DCR-TRV6/TRV6E/TRV11/ TRV11E/TRV20/TRV20E
RMT-808/809/811/812

SERVICE MANUAL

SUPPLEMENT-1

• Change of IC (Version up)

Page	FORMER	NEW
5-2

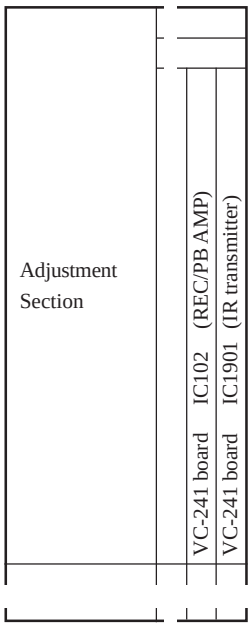
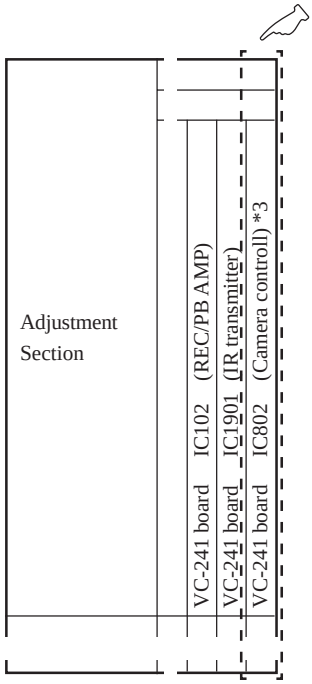
1-1. Adjusting items when replacing main parts and boards.

*3: When IC802 of the VC-241 board is going to be exchanged, the data on page : E, address : 53 and the data 6F must be modified. Be sure to enter the following data without fail.

1) Select page: 0, address: 01, and set data: 01.
2) Select page: E, address: 53, set data: 01, and press the PAUSE button.
3) Select page: E, address: 6F, set data: 82, and press the PAUSE button.
4) Select page: 0, address: 01, and set data: 00.
